CERTIFICATE OF APPROPRIATENESS**Application Date:** April 12, 2024**Applicant:** Tim Cisneros, agent for, Sonny BazBaz, owner**Property:** 3400 White Oak Dr, Lots 11 & 12, Block 279, Houston Heights Neighborhood Subdivision. The property includes a historic 9,640 square foot, two-story brick veneer commercial situated on a 13,198 square foot (132' x 100') corner lot.**Significance:** Contributing Storefront brick commercial, constructed circa 1930, located in the Houston Heights South Historic District. Approved COA in Dec. 2022 to remove non-historic brick on south elevation and install doors/windows on east elevation at existing and infilled openings. Approved at Nov. 9, 2023 for alteration to right (East) elevation ONLY.**Proposal:** Alteration: Storefront Front Façade, Side and Rear Elevations**Front (South) Elevation**

Recommendation: Approval

Existing Front (South) Elevation

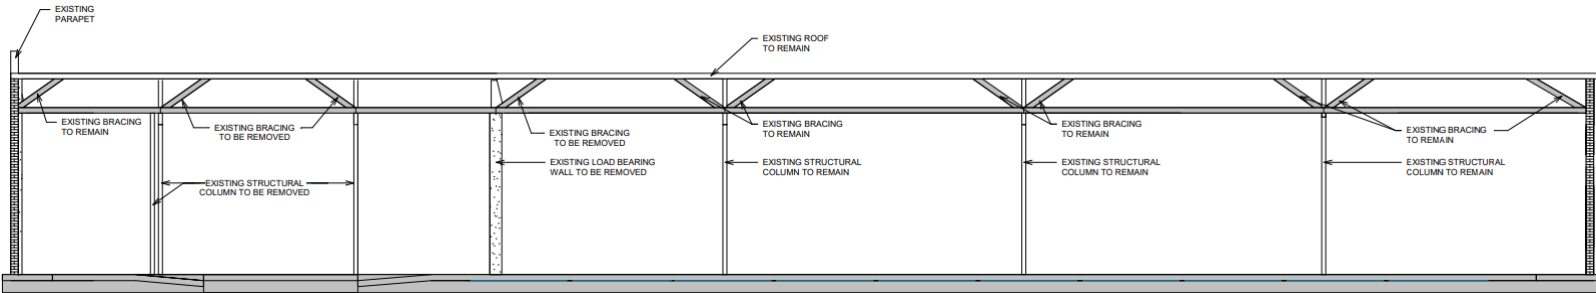
- (1) The proposed activity must retain and preserve the historical character of the property; The proposed front elevation preserves the historical character of the façade. A storefront is the most important architectural feature of historic commercial buildings.

Proposed Front (South) Elevation

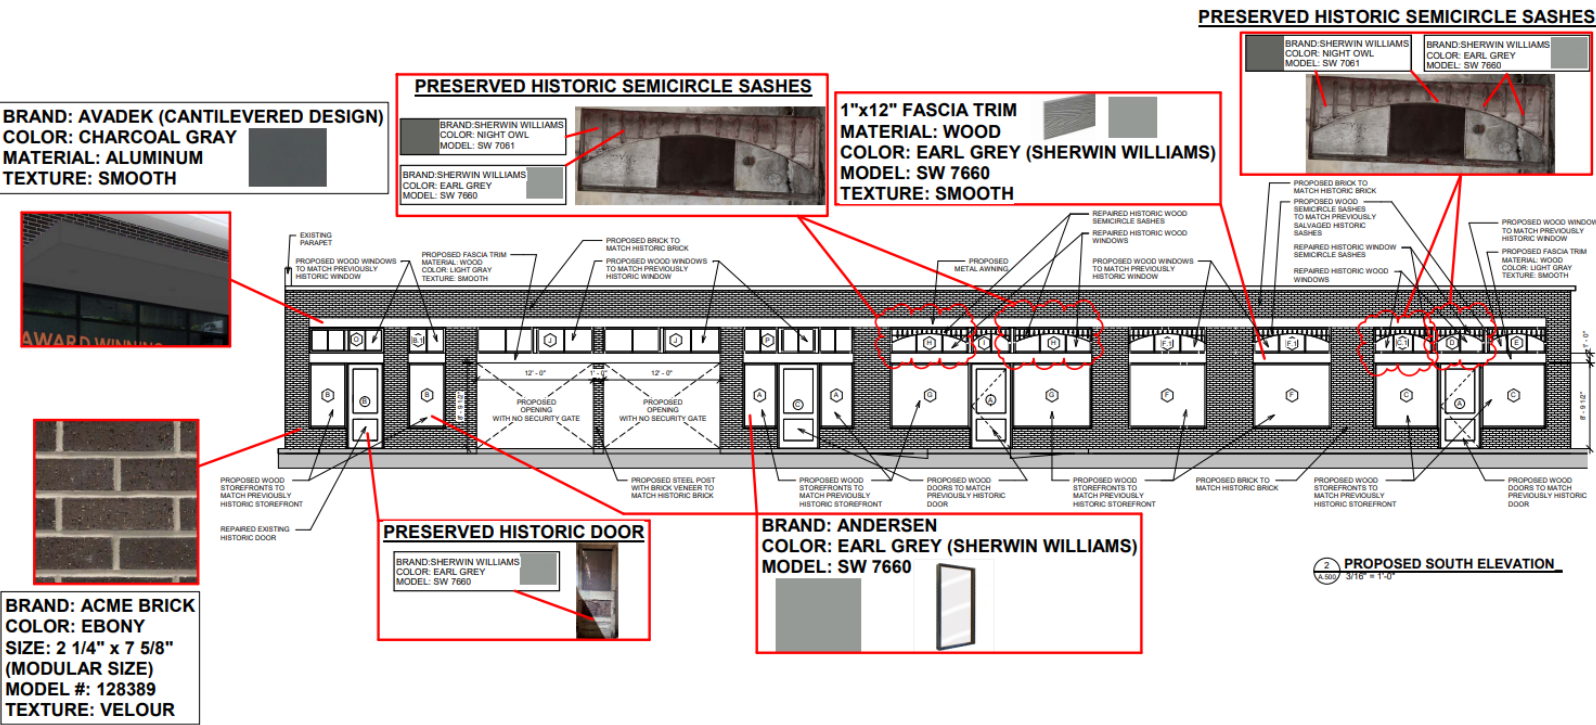
1. Propose Acme brick of Ebony color with a Velour texture
2. Propose an Avadek cantilevered awning of a charcoal gray color of aluminum material with a smooth texture extending 5' forward of front elevation

- a. Cantilevered awning situated above the transom windows
3. Propose sets of **transom windows** beneath proposed awning of varying dimensions ****progressing from left to right****

- a. Labeled O, 7'8" x 2'-7 1/2" divided into 4 lite patterns
 - b. Labeled B.1, 3'10" x 2'-7 1/2" divided into 2 lite patterns
 - c. Labeled J (above proposed garage door openings),

- i. 12' x 2'-7 1/2" divided into 4 lite patterns
 - d. Labeled P, 11'4" x 2'-7 1/2" divided into 6 lite patterns
 - e. Labeled H (beginning of arched transom windows)

- i. **This will be a restored arch window** as indicated by red, cloud outline on sheet A.500 (South Elevation) divided into 3 lite patterns
 - f. Labeled I, (beginning of arched transom windows)

- i. 4'0" x 2'-7 1/2" divided into 2 lite patterns
 - g. Labeled H (arched transom windows)
 - i. **This will be a restored arch window** as indicated by red, cloud outline on sheet A.500 (South Elevation) divided into 3 lite patterns

- h. Labeled F.1, (on right-hand side of drawing)
 - i. 8' 0" x 2'-7 1/2" divided into 3 lite patterns mimicking the historic, arched transom windows
 1. This is the location of where the modern-day garage bay opening once existed on the non-historic front facade

- i. Labeled C.1 (above door on right-hand side of line drawing)
 - i. **This will be a restored arch window** as indicated by red, cloud outline on sheet A.500 (South Elevation) divided into 3 lite patterns

- j. Labeled D, 5' 0" x 2'-7 1/2"
 - i. **This will be a restored arch window** as indicated by red, cloud outline on sheet A.500 (South Elevation) divided into 2 lite patterns

- k. Labeled E, 6' 0" x 2'-7 1/2" divided into 3 lite patterns mimicking the historic, arched windows
4. Propose fascia, wood trim board in the space between transom windows and storefront windows & doors in a light gray color with a smooth texture

5. Proposed storefront windows and doors ****progressing from left to right****
 - a. **All proposed storefront windows to be an earl grey color and a one lite pattern**

- b. Window labeled B, 3'10" x 6'8"
 - c. Door labeled B, 3'6" x 8'8" replicated door matching historic door
 - d. Window labeled B, 3'10" x 6'8"
 - e. Garage openings, 12' W x 8' 9-1/2" H

- f. Window labeled A, 3' 6" x 6' 8"
 - g. Door labeled C, 4' x 8' 8"
 - h. Window labeled A, 3' 6" x 6' 8"
 - i. Window labeled G, 8' 2" x 6' 8"
 - j. Door labeled A, 4' 0" x 8' 8"

- k. Same as letter 'i' above
 - l. Windows labeled F, 8' 0" x 6' 8"
 - m. Windows labeled C, 6' 8" x 6' 8"
 - n. Door labeled A, 4' 0" x 8' 8"

(2) The proposed activity must contribute to the continued availability of the property for a contemporary use;
(3) The proposed activity must recognize the building, structure, object or site as a product of its own time and avoid alterations that seek to create an earlier or later appearance; The proposed front elevation recognizes the building as a product of its own time. The existing openings (doors & windows) shows a distinguishing feature pattern of regularly spaced load-bearing brick columns, door openings, window openings, and window sashes, particularly on the right half of the façade where there exists semicircle sashes.

(4) The proposed activity must preserve the distinguishing qualities or character of the building, structure, object or site and its environment; The proposed front elevation preserves the distinguishing fenestration configurations and preserves the storefront's distinguishing architectural feature. Storefront doors were often flanked by large, display windows. Transoms above the display windows became key elements in early 20th century storefronts. These transoms of the past were used to permit air circulation into the store.

(5) The proposed activity must maintain or replicate distinctive stylistic exterior features or examples of skilled craftsmanship that characterize the building, structure, object or site; The proposed front elevation maintains and replicates the distinctive fenestration configurations.

(7) The proposed replacement of exterior features, if any, should be based on an accurate duplication of features, substantiated by available historical, physical or pictorial evidence, where that evidence is available, rather than on conjectural designs or the availability of different architectural elements from other structures; The existing front elevation shows physical evidence of a distinctive fenestration pattern including semicircle window sashes on the right half of the elevation. The proposed front elevation duplicates the existing fenestration openings which are supported by photographic evidence of once-existent door and window framing.

(9) The proposed design for any exterior alterations or addition must not destroy significant historical, architectural, archaeological or cultural material, including but not limited to siding, windows, doors and porch elements; Four semicircular window sashes will be restored and one door will be replicated.

Proposed Right (East) Elevation

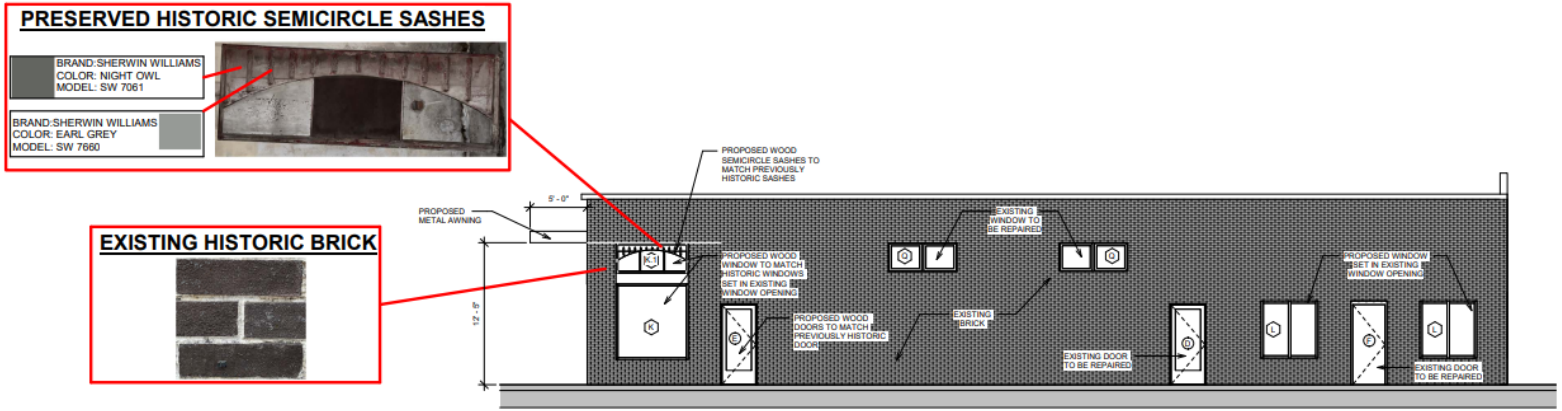
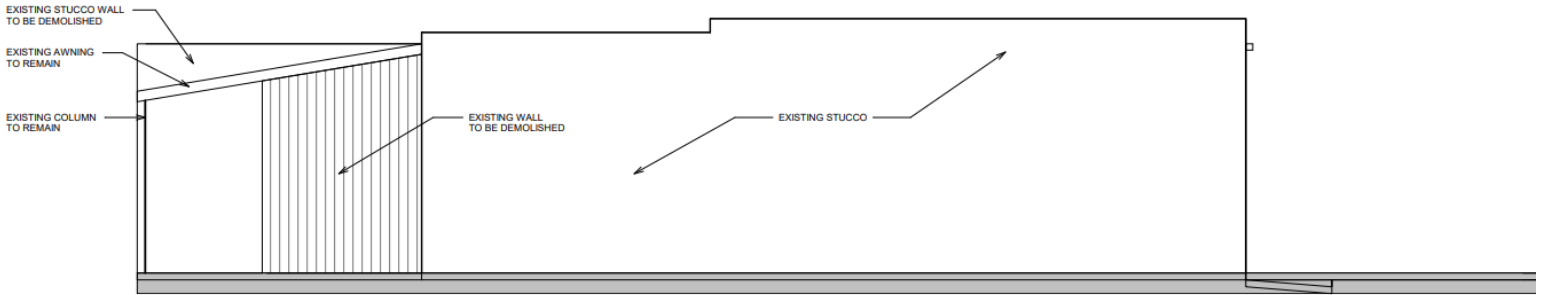
1. Right (East) elevation previously approved by HAHC on 11-9-2023
 - a. Revision to restore arched, transom window
 - b. A smooth, fascia, trim board between transom window and storefront window in a light gray color
 - c. Window labeled K, 6' 4" x 6' 7"
 - d. All other door and window openings are located in original locations from photographic evidence
 - i. See door and window schedule for details
2. Left (West) elevation
 - a. To remain unchanged
3. Rear (North) elevation
 - a. Remove infill and replace with windows
 - i. See door and window schedule for details
 - ii. Infill openings to remain unchanged
 - b. Right-hand side of rear elevation
 - i. Existing stucco wall to be demolished to expand section at rear with one new proposed column ****see sheet A.502****
